**PRE-APPLICATION CONFERENCE NOTES**  
**Aspen Avenue Subdivision (2023-002-PAC)**

Meeting conducted on Wednesday, January 11, 2023– 1:30 P.M.

Site Address	1319 Aspen Avenue, La Center, WA Parcel: 258891000
Legal Description	SW 1/4, S34, T5N, R1E and SE 1/4, S34, T5N, R1E
Applicant	Oleg Moroz Cross Construction LLC 360.601.6248 crossconstructionllc21@gmail.com 10009 NE 97th Court, Vancouver, WA 98662
Applicant’s Representative	David G. Spencer Jolma Design 360.953.8488 admin@jolmadesign.com 12306 SE Mill Plain, Suite 175M, Vancouver, WA 98684.
Property Owner(s)	George R. Spencer Bethany Spencer – Estate Administrator P.O. Box 306, La Center, WA 98629.
Proposal	The applicant proposes to subdivide the property into 16 lots for single-family detached residences in the LDR-7.5 zone. The site would be accessed via two public cul-de-sacs from Aspen Avenue with the southern cul-de-sac having two private roads extending from the cul-de-sac.
Date of Issue	January 26, 2023

**Figure 1. Site Slopes**

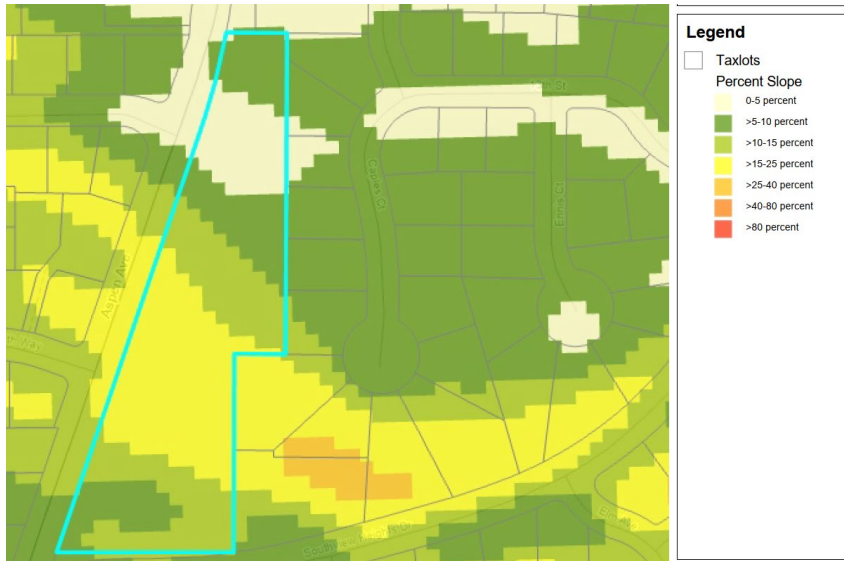
Critical areas mapped for the project on the project site by Clark County Maps Online are limited to a category II CARA. No other types of critical areas are mapped on the project site. However, site slopes may be as steep as 25 percent as shown in Figure 1 below, which may meet the City's definition of a landslide in LCMC 18.300.030.

Because onsite slopes are steep, the applicant is required to provide a geotechnical report assessing the potential for landslide hazards. If a landslide hazard exists, the applicant's report should address LCMC 18.300.090(4) including alterations to geologically hazardous areas (b). general design standards for landslide and erosion hazard areas (c) and design standards for landslide hazards (d).
